2025. Nov.24<sup>th</sup>  
Nippon chemicon Co., Ltd.

### Announcement Regarding Reel Shape Change

Chip-type aluminum electrolytic capacitors, sizes  $\Phi 12.5$  to  $\Phi 18$ ,  $\Phi 380$  reel packaging

**Details of Mold Changes for MV2 Reels (RRM32G/RRM44G)**

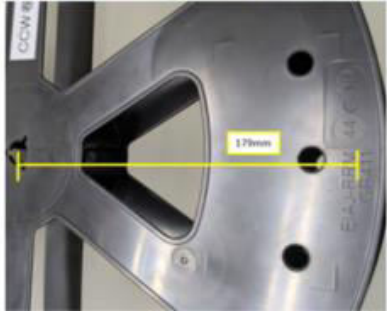
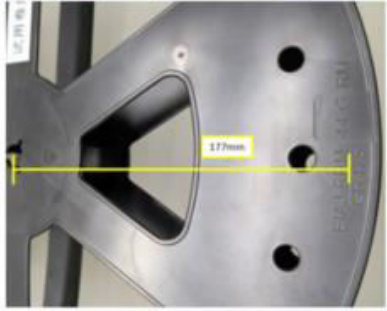
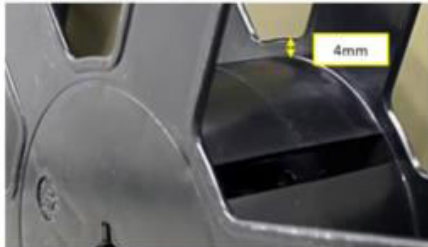
- ① Eliminate the label application guide for the part number stamping area
  - ② Slightly adjust the part number stamping position
  - ③ Change the dimensions of the inner flange section on the reel side plate
  - ④ Eliminate the circular groove on the inner flange section
- Material and other dimensions remain unchanged.

No	Details of Changes	After change		Benefits after the change
		Before change	After change	
1	<p>Remove the label attachment frame on the part number stamp side</p> <p>*The frame behind the part number stamp will remain</p>			<p>Preventing customer label placement errors</p>
2	<p>Dimension correction from reel center to bottom of engraving (EIAJ-RRM XXG-NM) (179mm ⇒ 177mm)</p> <p>*Only the engraving position changes; the reel outer diameter remains unchanged.</p>			-
3	<p>Inner Flange Diameter Change (φ88mm ⇒ φ96mm)</p> <p>*Center hole dimensions remain unchanged.</p>			<p>Reducing the incidence of reel deformation</p>
4	<p>Remove the circular groove on the inner flange section</p>
